Deans Farm, Bilstone

Conversion of existing building & creation of associated parking

Proposed Floor Plans & Elevations

Scale	Date	Drawn	Job	Drawing
1:100	May 2024	IDR	7406	270A

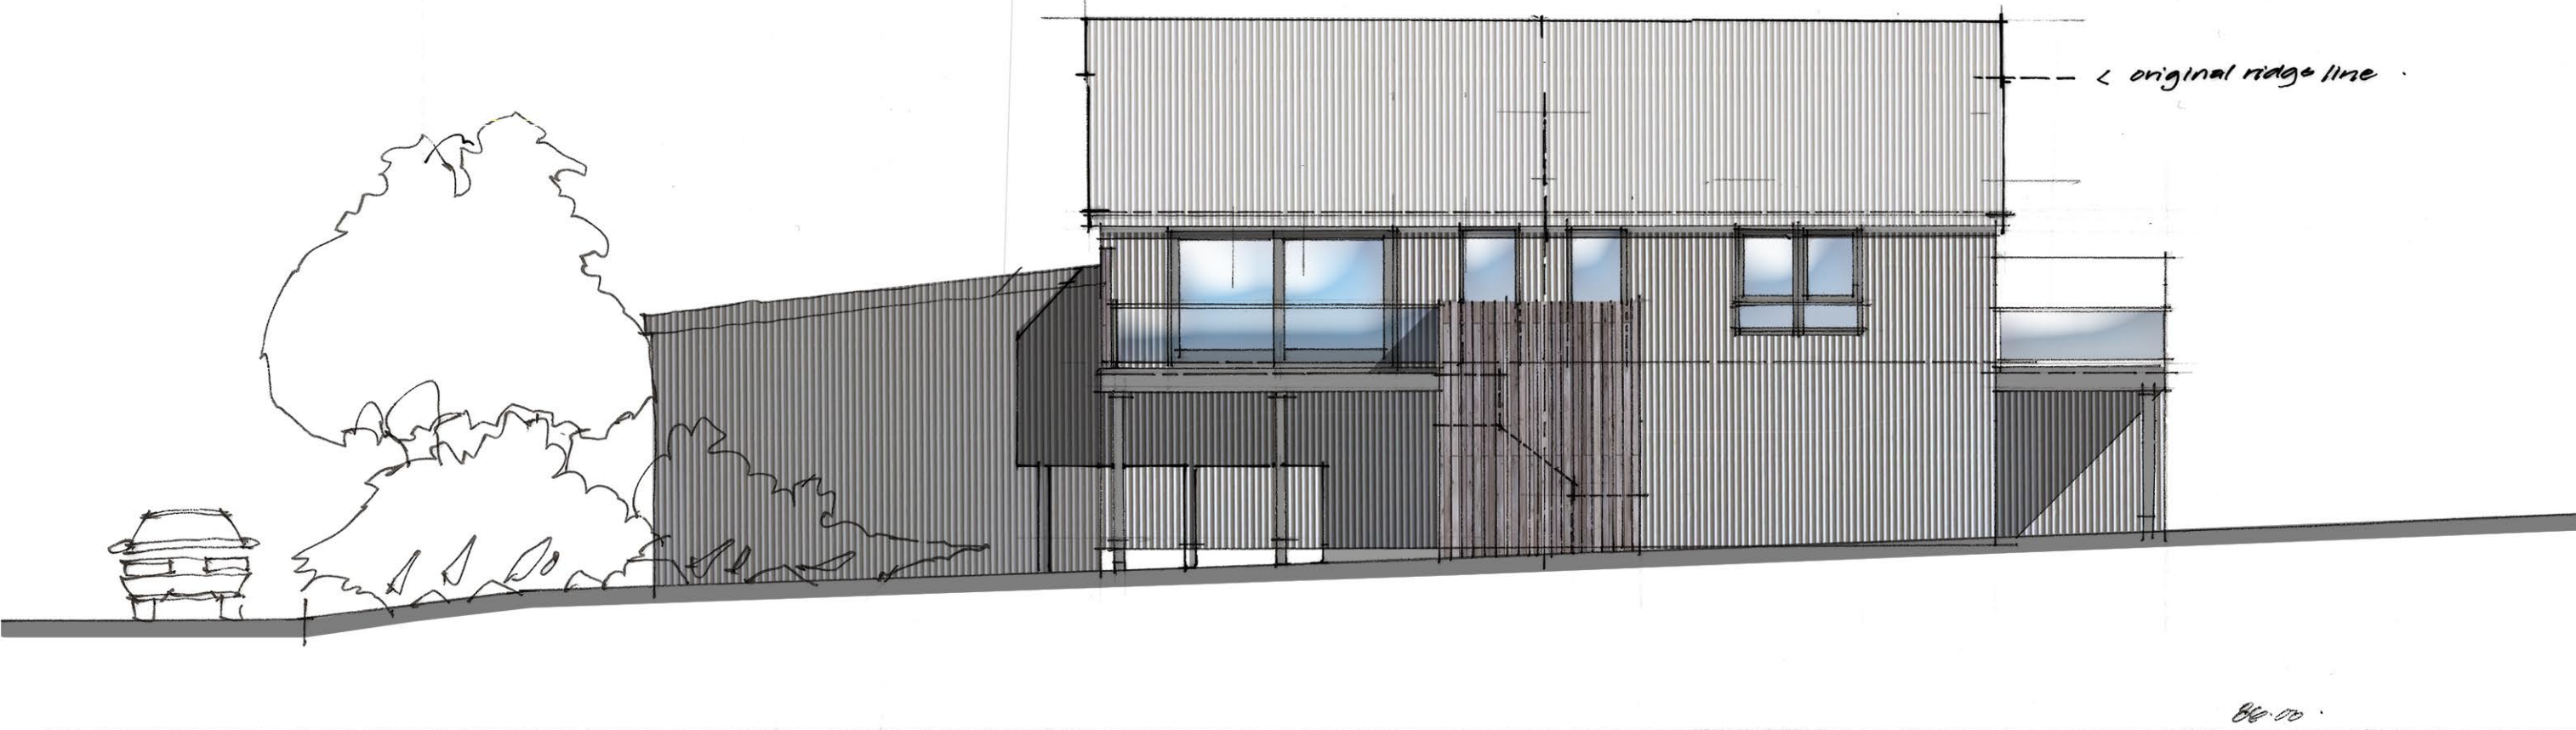
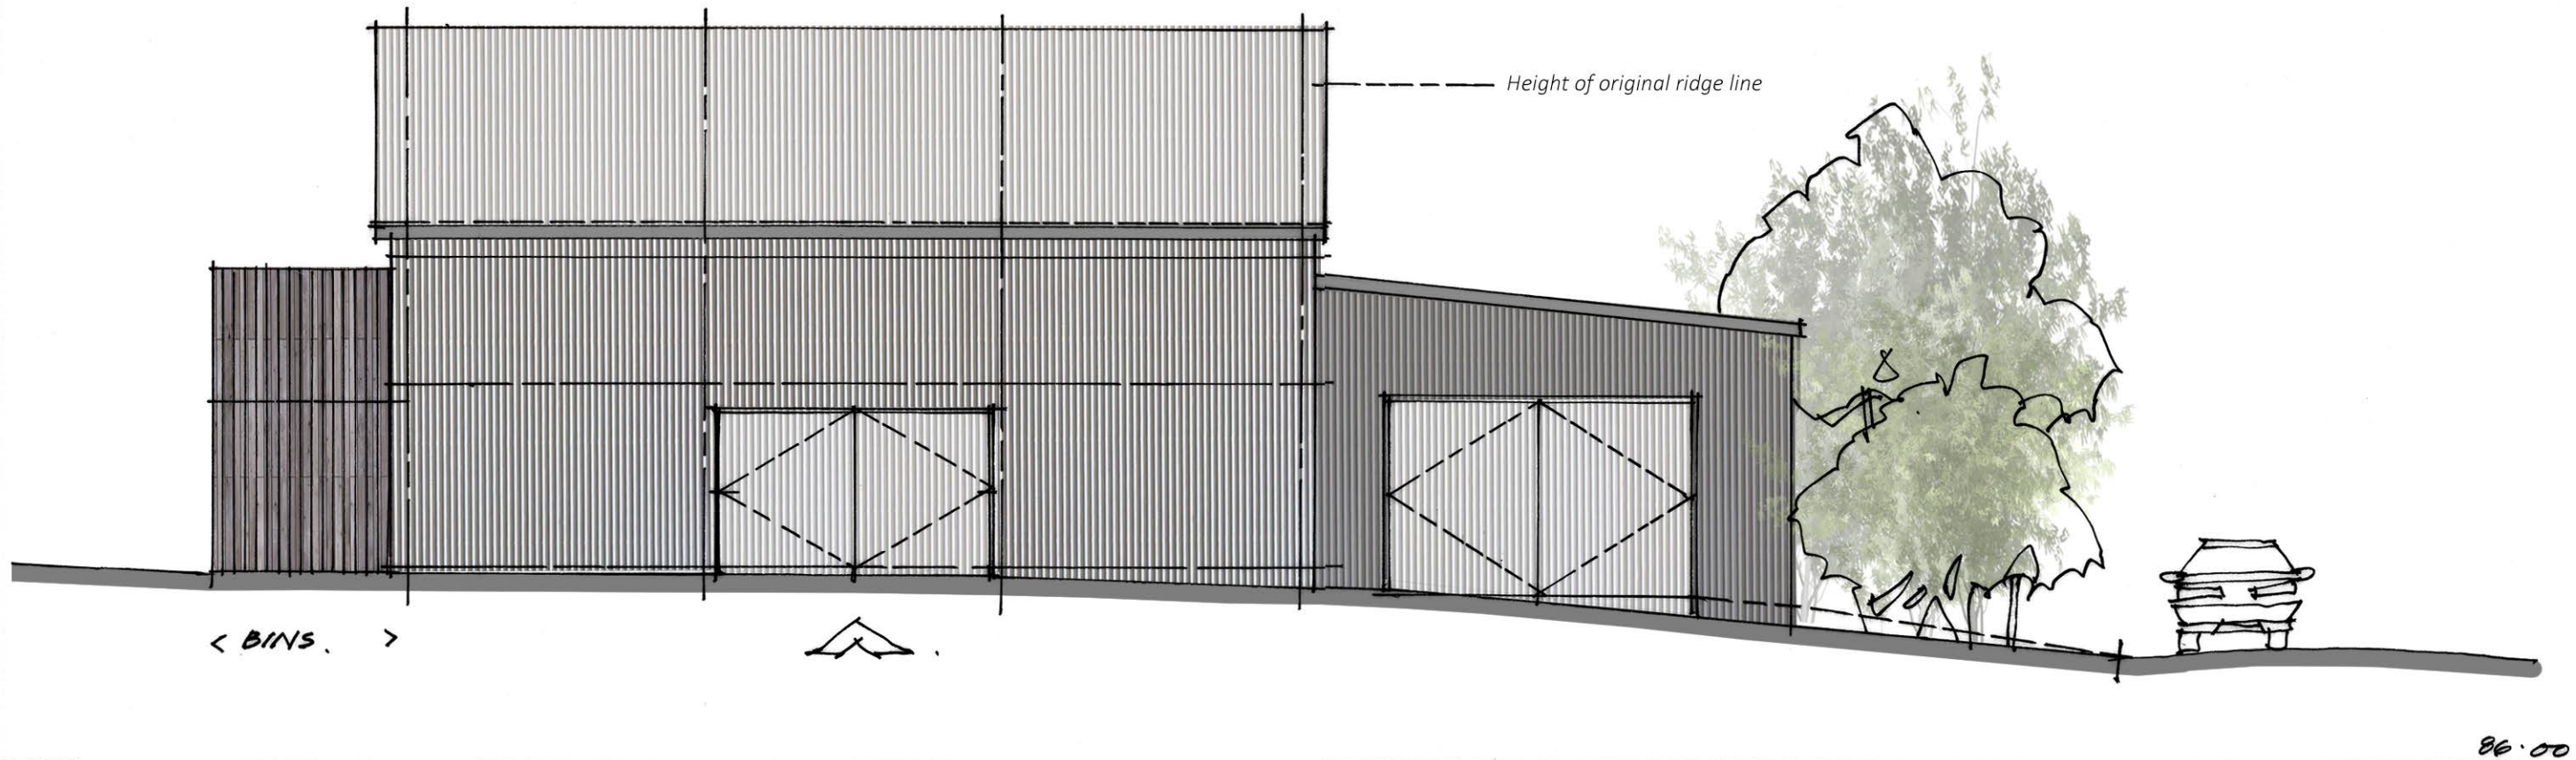
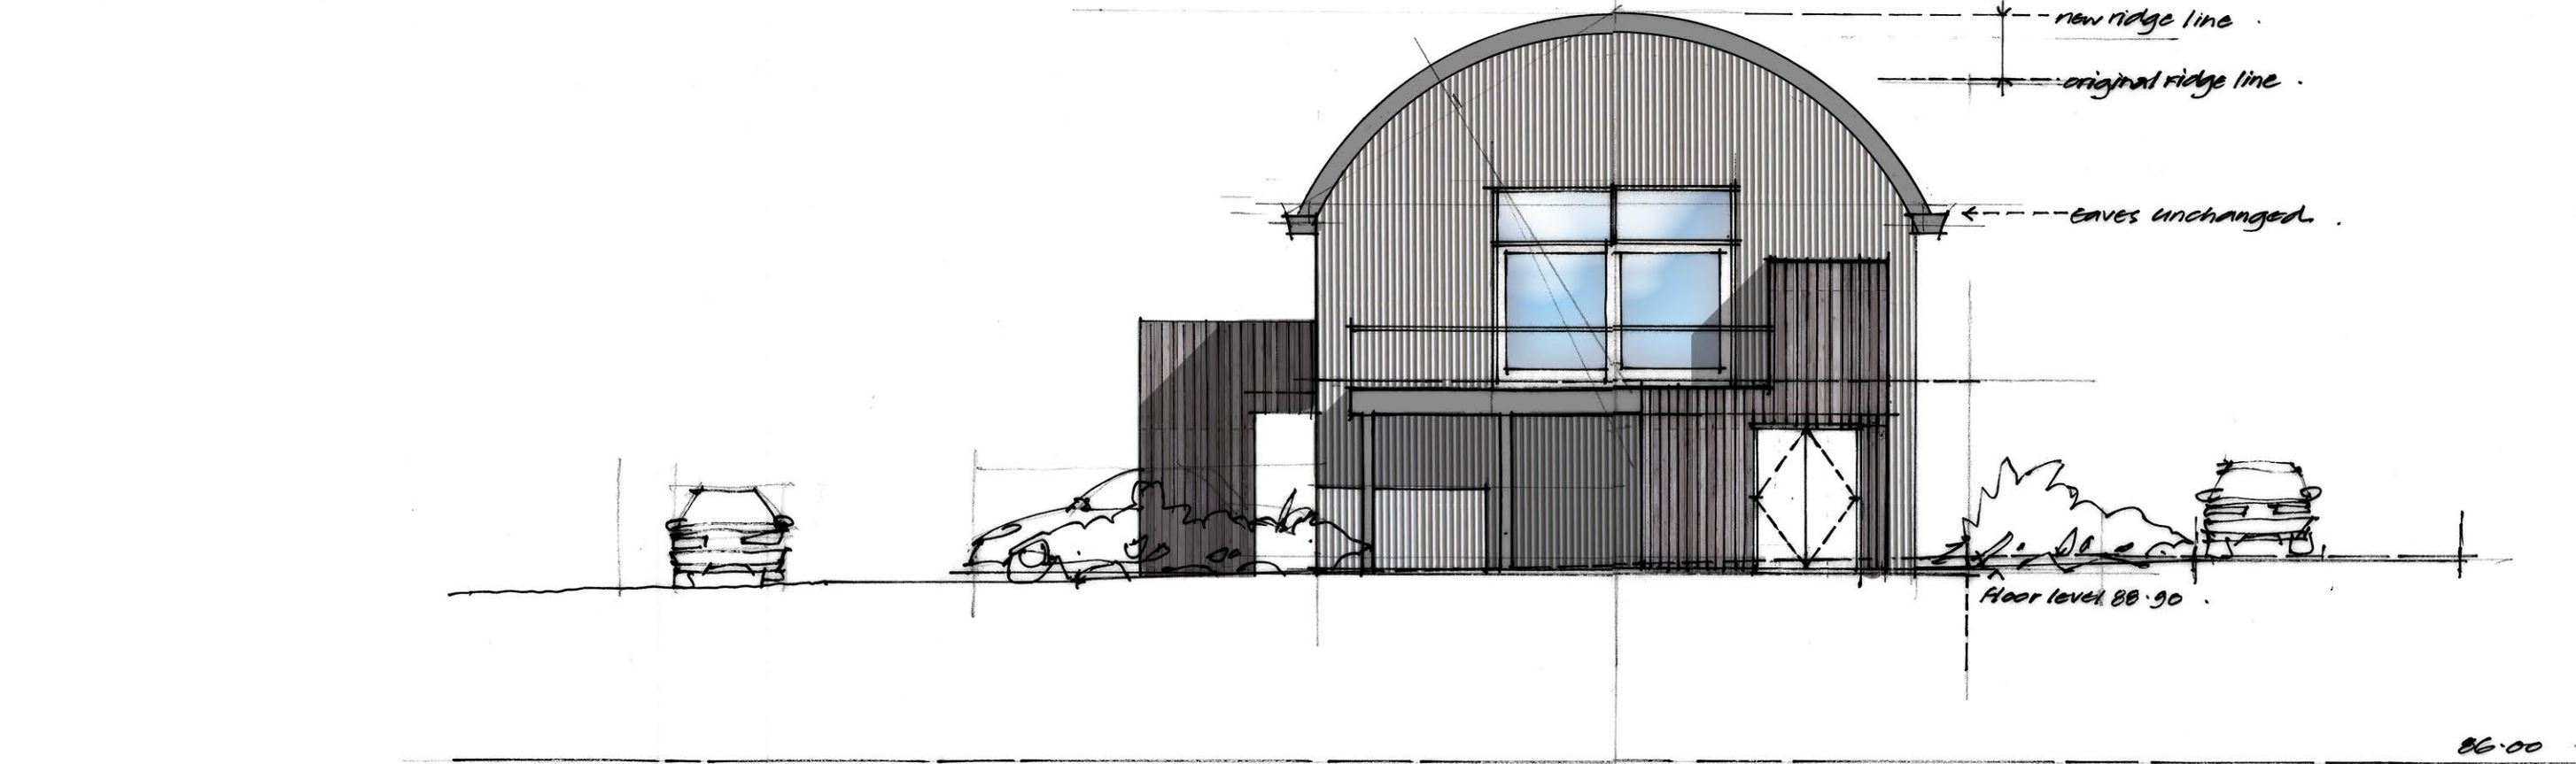
Further to planning approval 23/00037/FUL as a part of developing the Construction drawings in conjunction with the Structural Engineer, it has become apparent that the existing curved roof needs to be replaced. This is due to the need to comply with Building Regulations and to work with the existing main structure.

Consequently, the design of the new roof incorporating insulation and meeting the Engineers requirements results in a change in the curvature and a modest increase in the overall ridge height which will be largely unnoticeable due to the impact of natural perspective.

THERE WILL BE NO CHANGES AT EAVES LEVEL OR BELOW
